Item # 3
MCPB 06-03-04

MEMORANDUM

REVIEW TYPE: Site Plan Review
CASE #: 8-04029
PROJECT NAME: Liberty Heights (Lots 106 through 116)
APPLYING FOR: Approval of 11 townhouses

PROJECT DESCRIPTION: Proposal

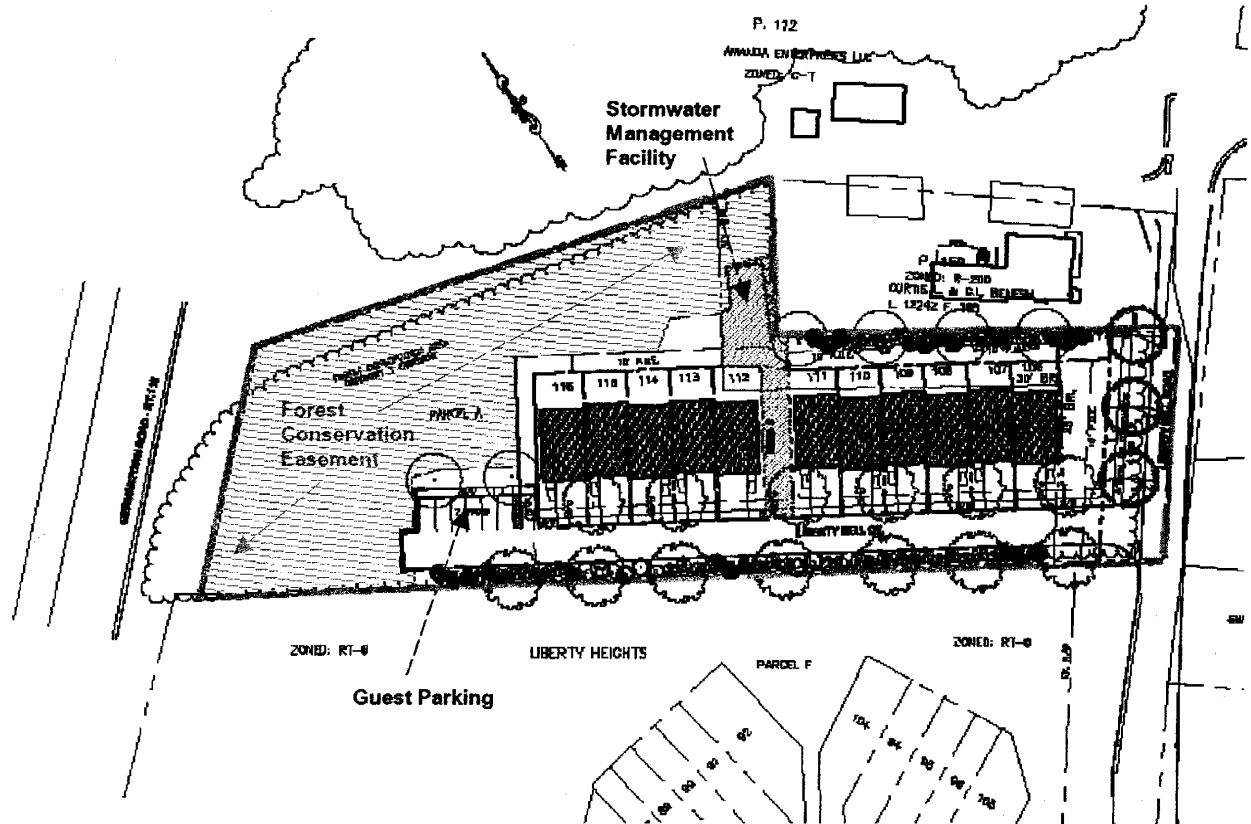
The subject site plan application proposes 11 one-family attached dwelling units with garages in two rows. Access to the units will be via a driveway from Liberty Mill Road. Seven visitor parking places are provided in the rear of the property. A sidewalk will be constructed along the driveway and connecting to the future sidewalk along Liberty Mill Road.

A mix of shade and evergreen plant materials are proposed along the south and north property lines to provide buffer between the proposed townhouses and adjacent properties. The applicant will retain 0.63 acres of forest on the site, which will be placed into a Category 1 forest conservation easement. The site plan shows a road dedication of 35 feet from the center line of Liberty Mill Road.
